# Service BULLETIN

APPLICABLE TO 64348, 64349 & 64049  
NOZZLES AS OUTLINED BELOW

SB3480801A  
Nov. 1, 1998

## REVISION TO AUGUST 1, 1998 BULLETIN! NEW TWO-PIECE HANDLE BREAKAGE REPORTED

**FIGURE 1**

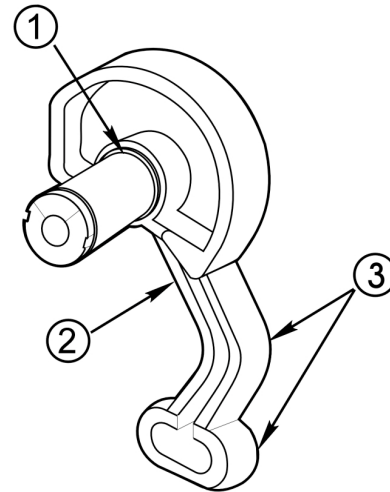
It has been reported that several of the newer 220878-1 handles have been broken on nozzles installed on hose reel applications. Reports of leakage from the handle shaft area were initial signs of breakage. Reports of the single screw coming loose were also signs of the breakage. The handle is an integral part of the nozzle interlock system. The breakage, result of mishandling (dropping), has occurred at a machined radius area "1", as shown in Figure 1 on the next page. If not detected, further use can cause

the handle to loosen and overcome the interlock system. The result can then be a possible spill since it can then be possible for the operator to take the nozzle off of the aircraft with the nozzle poppet in the open position. The breakage has been the result of impact on the handle in the areas marked with a "3", Figure 1. The handle first bends until it contacts the carrying handle or sometimes the bolt head attachment of it. The bolt head impact results in an impression in the handle and produces a stress riser in the area marked "2" which may result in the handle breaking at that point. This is a maintenance problem but not a safety issue. Further impacts in the areas marked "2" and "3" can result in the fracture at "1" which is the object of this bulletin. All operators should be provided the following information (instructions) to prevent spills and possible bodily injury from spilled fuel:

The design of the handle does not allow for any other type of manufacturing (within cost limits) than die-casting. The material of all three types of handles, although much stronger than an aluminum die casting, has minimum ductile properties (properties that allow bending rather than breakage). The solution to the problem therefore is to change to a more ductile material that will allow for severe bending but no breakage within the physical limits of the geometry of the handle installation. This will prevent the potential spills now apparently possible. When the handle is bend beyond use (and does not break) then it will have to be replaced. Preventing the operator from dropping the nozzle will minimize the maintenance costs greatly. If a hose end regulator is also used then the installation of a drag ring will also prevent the handle from being damaged. Ask your Carter distributor for more information on this possibility. The drag ring, as it is apply named, is a sacrificial part that prevents wear from dragging the nozzle while rewinding the hose reel.

The new more ductile material will be available shortly. It will easily be identified since it will be black in color in lieu of the normal gray aluminum color of the existing one. The part number will remain the same and all future production nozzles will be fitted with the new handle. Return any broken handles (in the area marked "1" only) to your Carter distributor for a free replacement kit to upgrade the nozzle. Replacement kits, KD64349-12, will be used to replace the broken handles. The kit will contain the parts needed to replace the handle and attaching parts only. All future orders for 220878-1 Handles will be filled with the newer material.
